Product Change Notification (PCN)

PCN #: 3A-2020

DATE: 04/24/2020

5.1 Top Level Part Number Changes (packaged kits)

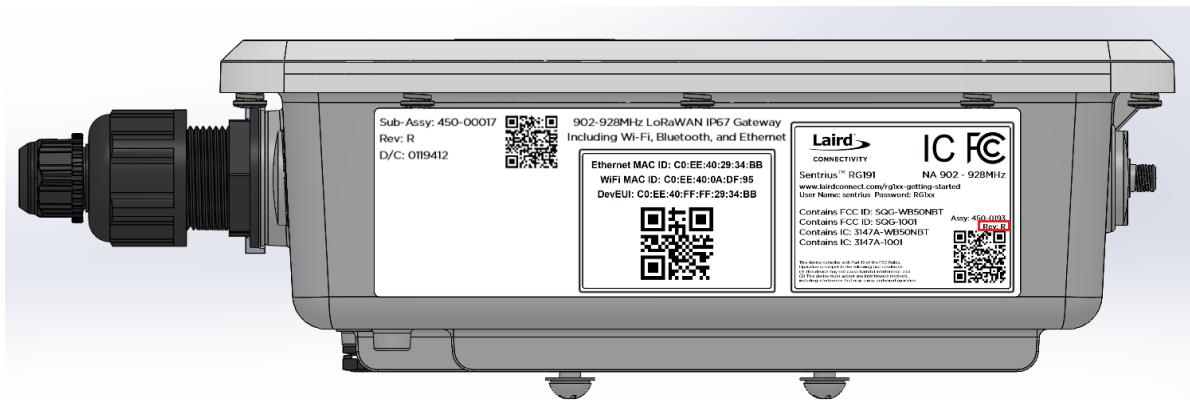
- Revision change available as revision number printed on kit content label for all kits Specific kit part number and revision printed on the label within red square area.

Note: Revision show on label is for reference only. Part number and revision will change based on the kit purchased.
